**Our Case Number:** ABP-314056-22

**Re:** Liffey Valley to City Centre Core Bus Corridor Scheme.  
Fonthill Road to High Street all in the County of Dublin.

**Re:Submission–Objection to the development consisting of the construction of the Liffey Valley to City Centre Core Bus Corridor Scheme.**

Planning Reference no: Ref No. PL29N. PA0043 drawing No: NPH-T-ARUP-00-ST-0002 copy below

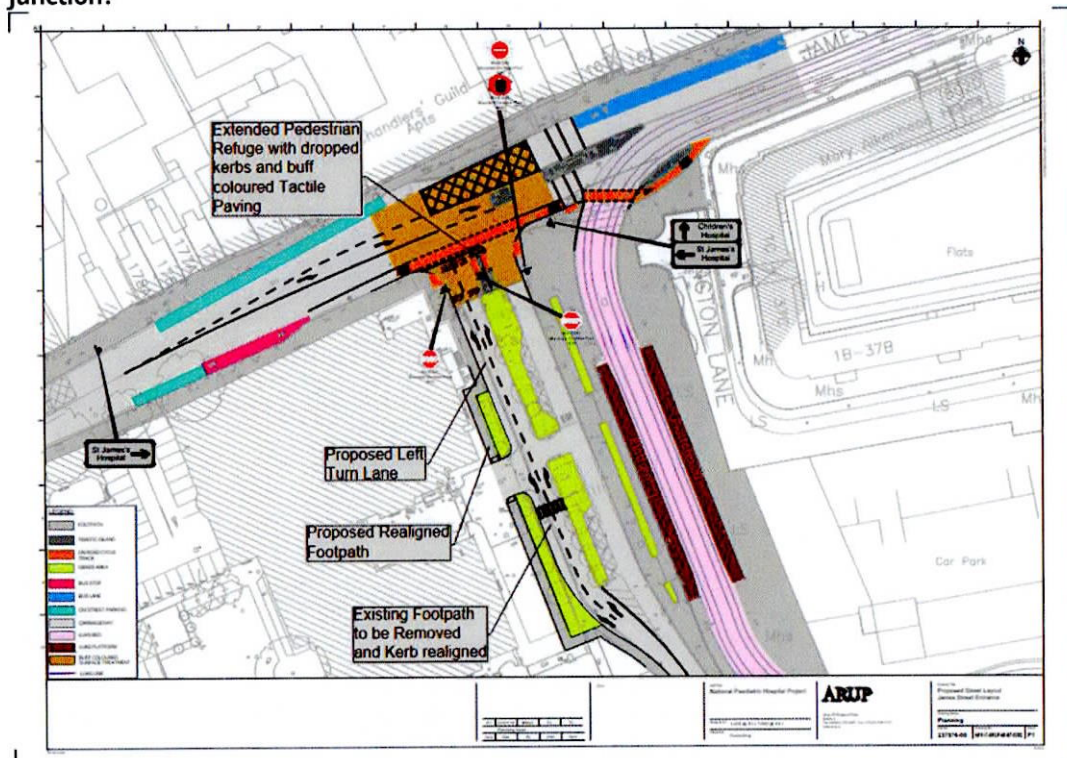
- The new children's hospital (NCH) planning permission requires an additional traffic lane to be added at the St James Hospital (SJH) junction. This was proposed to allow cars exiting west leave the campus and not back up behind cars waiting to turn right towards the city. The traffic lights at this junction are red a lot to prioritise the Luas line crossing causing a big tail back into the SJH site and James Street.

The traffic numbers in the EIS and as presented at the oral hearing for the New Children's Hospital claimed that this was necessary due to the volume of traffic predicted as SJH will only have the one access / exit route once the through road from Rialto gate in the hospital is closed to general traffic. In the evenings it was estimated by the NCH that an additional 140 cars PER HOUR from SJH would be using this exit to turn left, this is in addition to the bumper to bumper traffic heading out of town. How can the Bus Connects proposal, if approved, be allowed to make this current situation worse by preventing a left turn in the evenings?

**How can 2 different planning permissions co-exist for the same site and same busy traffic junction?**

As part of the planning application for the New Children's Hospital (NCH) Planning Application Ref No. PL29N. PA0043 these trees were to be retained. See EIS and drawing number NPH-L-BDP-PL-ZZ-ST-9401. Copy below

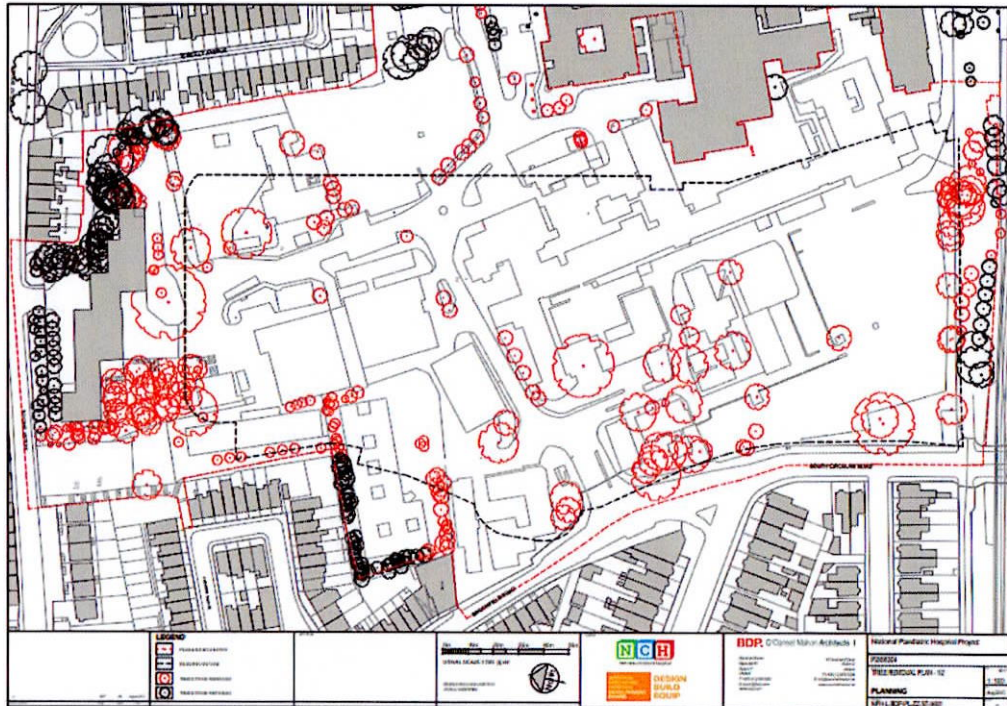
3. The proposed westbound bus gate location at the new entrance to the New Children's Hospital bus gate at Mount Brown involves the removal of trees outside the St. James Hospital Energy Centre to facilitate the construction of a new slip road.

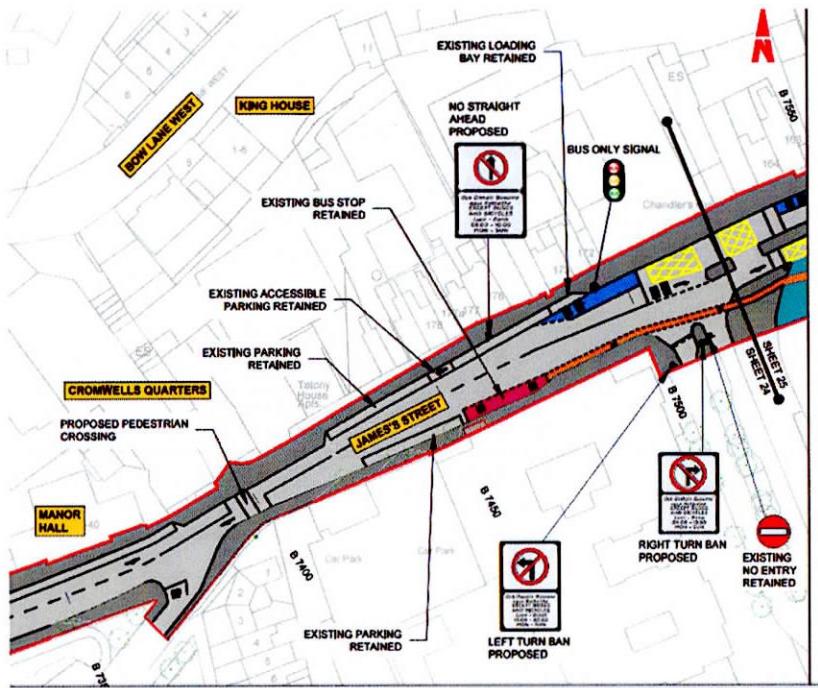
- The submitted drawing no BCIDB-JAC-GEO\_GA-0007\_XX\_00-DR-CR-0024 sheet no 24 Of 28 is flawed and should invalidate the application as NO bus gate is located or referenced on the drawing at the St James Hospital entrance. The westbound bus gate at the NCH Mount Brown entrance is shown and referenced on drawing no BCIDB-JAC-GEO\_GA-0007\_XX\_00-DR-CR-0023 sheet no 23 Of 28.

**\*\*THIS SHOULD INVALIDATE THE APPLICATION or as a minimum REMOVE THE BUS GATES ELEMENT FROM THIS PLANNING APPLICATION\*\***
